CLUB RACING BOARD MINUTES | February 2, 2016

CLUB RACING TECHNICAL BULLETIN

DATE: February 20, 2016
NUMBER: TB 16-03
FROM: Club Racing Board
TO: Competitors, Stewards, and Scrutineers
SUBJECT: Errors and Omissions, Competition Adjustments, Clarifications, and Classifications
All changes are effective 3/1/2016 unless otherwise noted.

***Figure 1: SMG Strut housing with Slotted Upper Hole.
(Note: Jri housings have the slot on the bottom hole)***

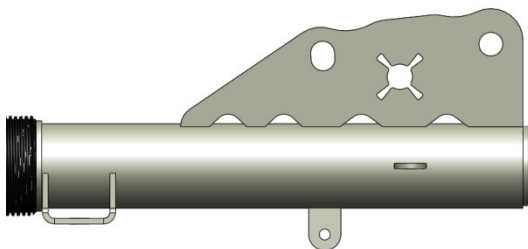
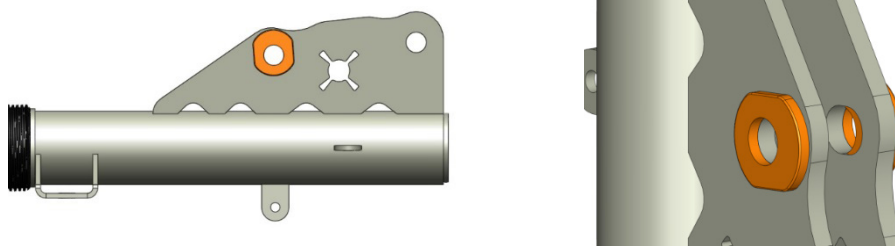
In Appendix M SMG Technical Regulations, section 2.g.4., make the following changes:

~~"The Cortex Kit caster/camber plates set allowing a maximum of 3.0 degrees of negative camber. **Maximum negative front camber is 3.5 degrees. The approved technique to accomplish this is by using the Cortex P/N CFS-40-ALIGN-SMG, SMG alignment kit (which includes camber slugs P/N CFS-40-1010), in all SMG strut housings. Installation guidelines are provided by Cortex Engineering. The Jri front strut housing will already have this feature. This CFS-40 kit is allowed, not required. But this IS the only allowed means to go beyond 3.0 degrees of negative camber. Potential tire clearance issues, resulting from this modification, are addressed in Section: o.**~~

No machining of body to allow further travel. Caster: min. +6.35 max. +7.85 Camber plate PN MM5CC-5 or CCP197-05-09.

Illustration of strut housing modification discussed in section g.4.:
